HISTORIC AND DESIGN REVIEW COMMISSION

May 17, 2023

HDRC CASE NO: 2023-163
ADDRESS: 814 LAMAR ST
LEGAL DESCRIPTION: NCB 1654 BLK B LOT 4
ZONING: R-5, H
CITY COUNCIL DIST.: 2
DISTRICT: Dignowity Hill Historic District
APPLICANT: Fernando Botello
OWNER: OMAR BIBIAN/MATER-MAC, LLC
TYPE OF WORK: Addition, fenestration modification, gable modifications, porch modifications
APPLICATION RECEIVED: April 12, 2023
60-DAY REVIEW: Not applicable due to City Council Emergency Order
CASE MANAGER: Jessica Anderson
REQUEST:

FRONT ELEVATION
SCALE:-----1/4"=1'-0"

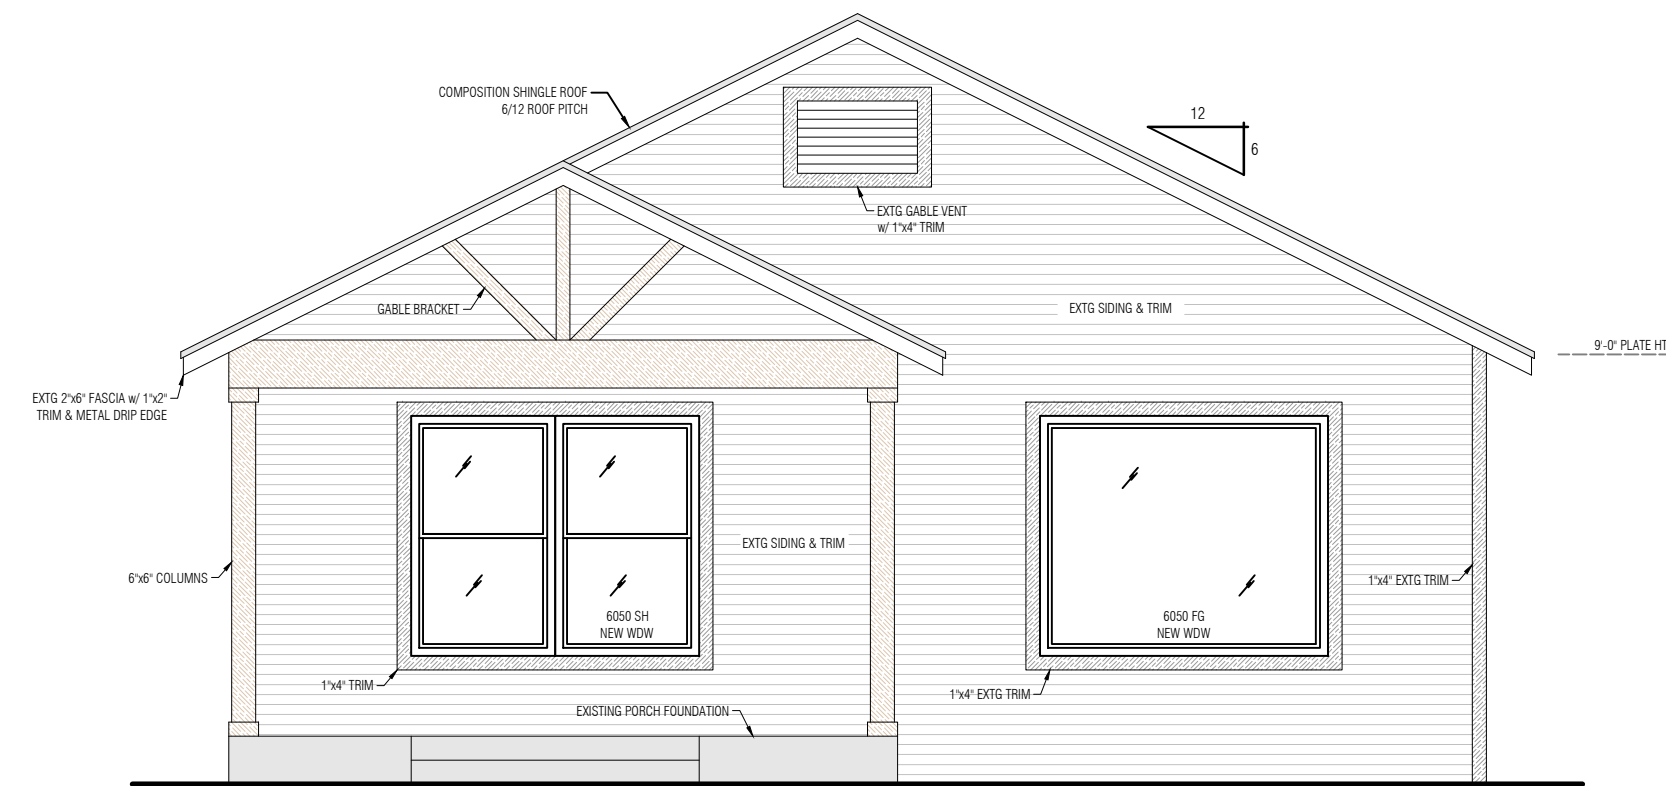
- e. **GABLE TREATMENT:** The applicant proposes to add faux timbering to the front-facing gable. Historic Design Guidelines for Exterior Maintenance and Alterations 7.B.iv says do not add new elements and details that create a false historic appearance. Faux timbering is not historically found on Craftsman-style homes. Staff finds the request does not conform to guidelines.

- f. **WINDOWS (EXISTING):** The applicant proposes to infill three existing wood windows on the east elevation and one existing wood window on the west elevation, replace an existing one-over-one wood window on the primary elevation with a pair of ganged one-over-one windows, and replace an existing ganged pair of one-over-one wood windows with a fixed-lite window. Historic Design Guidelines for Exterior Maintenance and Alterations 6.A.i says to preserve existing window and door openings, and to avoid filling in historic door or window openings. Staff finds the requests to modify the existing window patterns do not conform to guidelines.

- g. **FRONT DOORS (INFILL):** The applicant proposes to infill the street-facing front door. Historic Design Guidelines for Exterior Maintenance and Alterations 6.A.i says to preserve existing window and door openings, and to avoid filling in historic door or window openings. Staff finds the request to infill the street-facing door does not conform to guidelines.

- i. **ROOF (DETAILS):** The applicant proposes to add fascia boards to enclose the existing exposed rafter tails on the east and west sides of the roof. Construct a 425-square-foot rear addition with porch. 3.B.iii says to preserve and repair distinctive roof features such as cornices, parapets, dormers, open eaves with exposed rafters and decorative or plain rafter tails, flared eaves or decorative purlins, and brackets with shaped ends. Staff finds the request does not conform to guidelines.

Staff does not recommend approval of items 4 through 8, based on findings e through g.

Staff does not recommend approval of item 10, adding fascia boards to enclose the existing exposed rafter tails, based on finding i.

ROOF PLAN LAYOUT

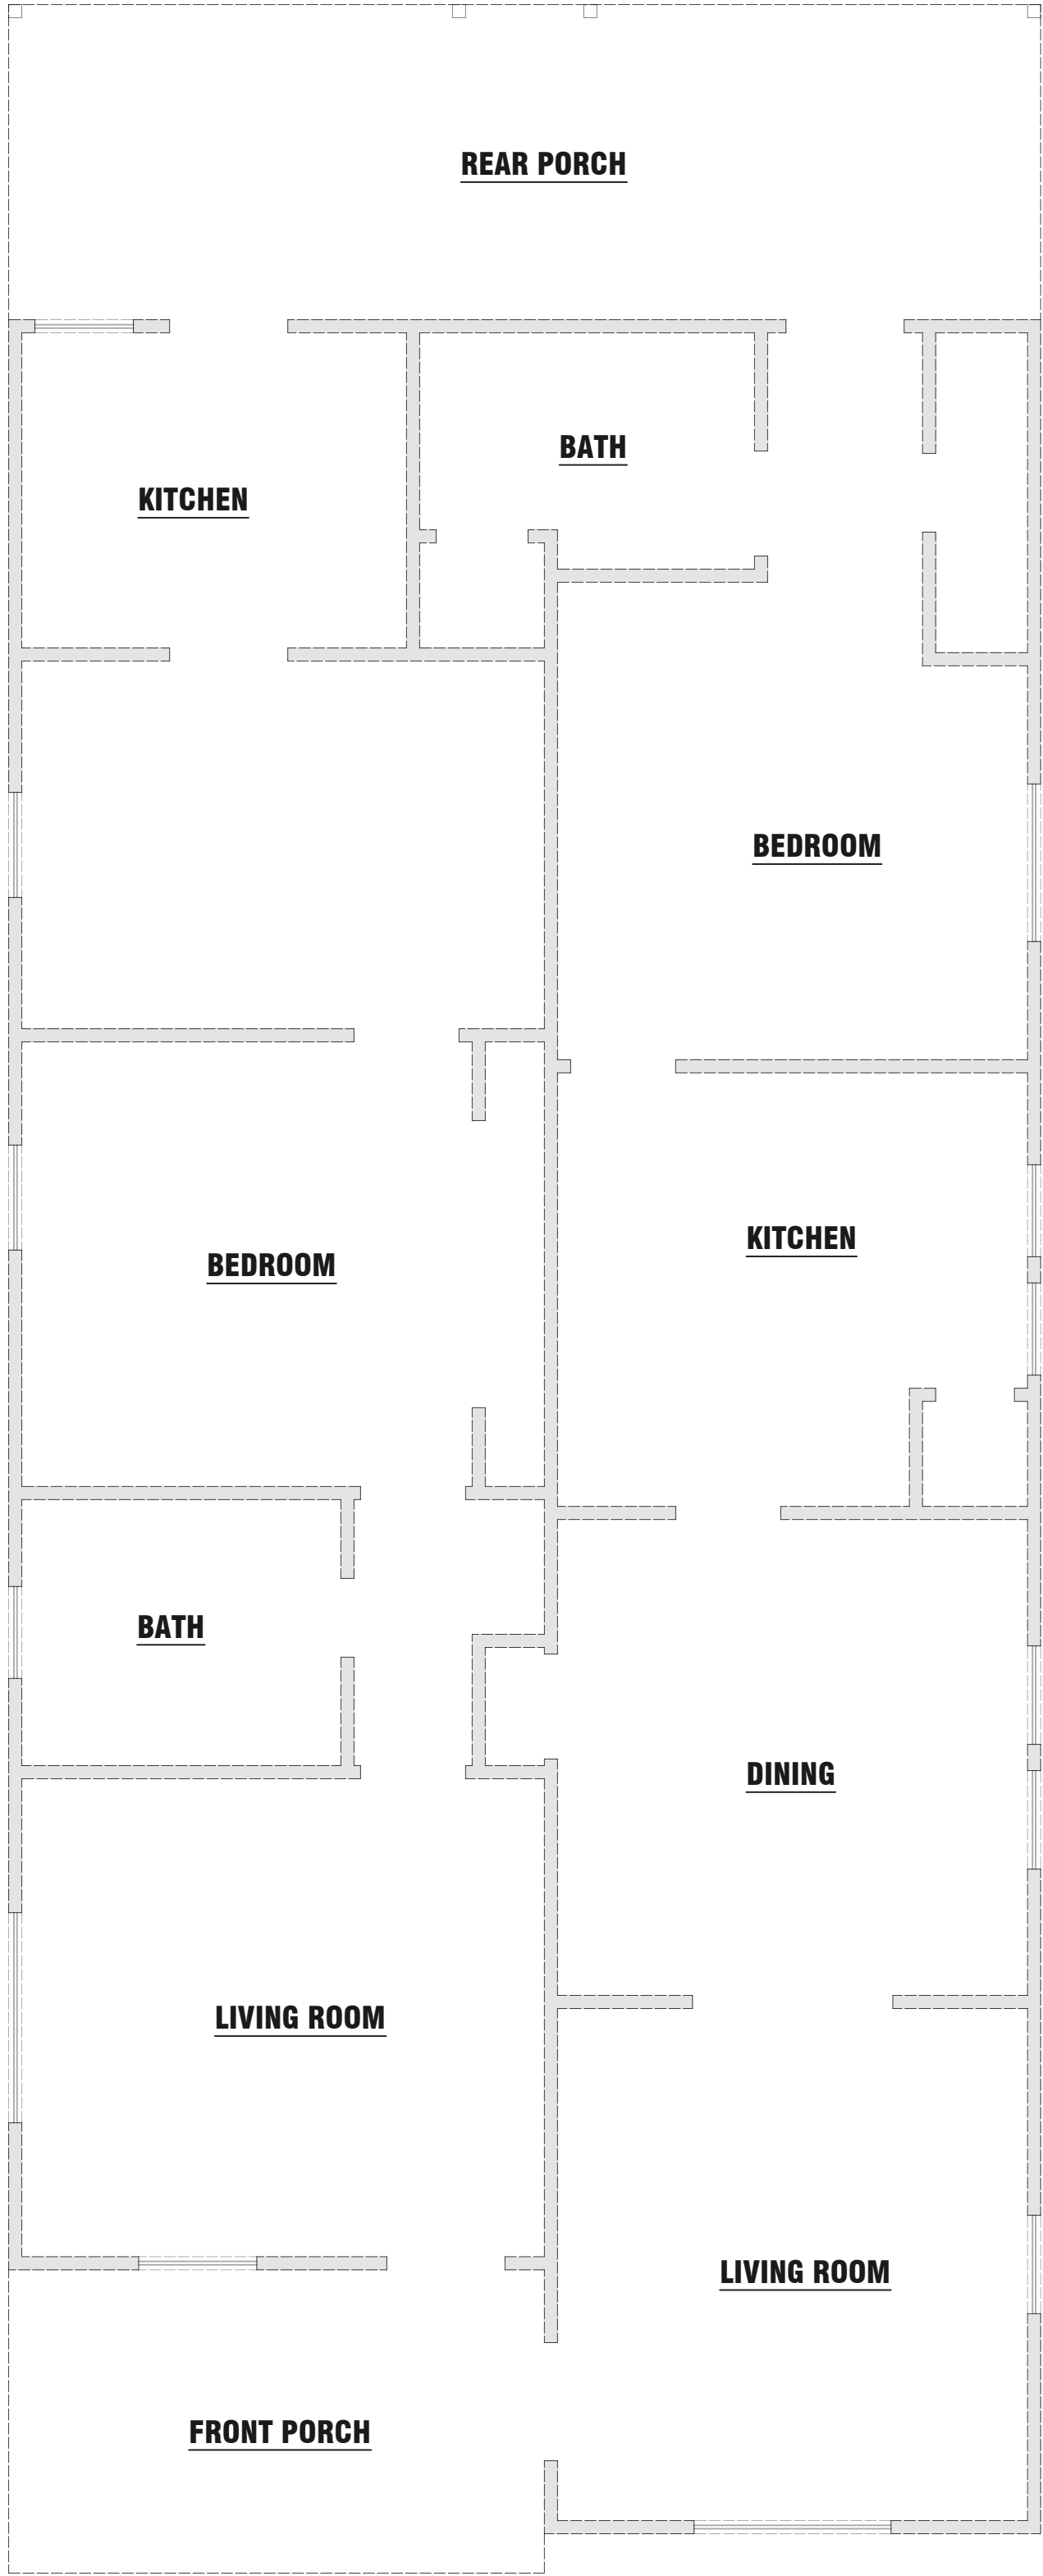
- j. **ADDITION:** The applicant proposes to construct a 425-square-foot rear addition with porch. The addition is to feature trim and siding to match the historic core of the property, an inset porch with a 6"x6" wood column, and a back door. Staff finds the addition generally appropriate, but that the exposed rafter tails found on the historic core be continued on the proposed additions.

- i. That the exposed rafter tails found on the historic core be continued on the proposed additions.
- ii. That the applicant propose a window product that conforms to standard specifications, namely a wood or aluminum-clad wood product.
- iii. That in place of the proposed fixed clerestory window, the applicant propose a small one-over-one wood or aluminum-clad wood window similar to those used historically on Craftsman homes for bathrooms.
- iv. That the proposed wood columns be no wider than 6" square, and feature both capital and base trim and chamfered corners.
- v. That the applicant submit materials specifications and/or a cut sheet for the proposed rear door.
- vi. That the applicant submit materials specifications for the proposed rear porch.
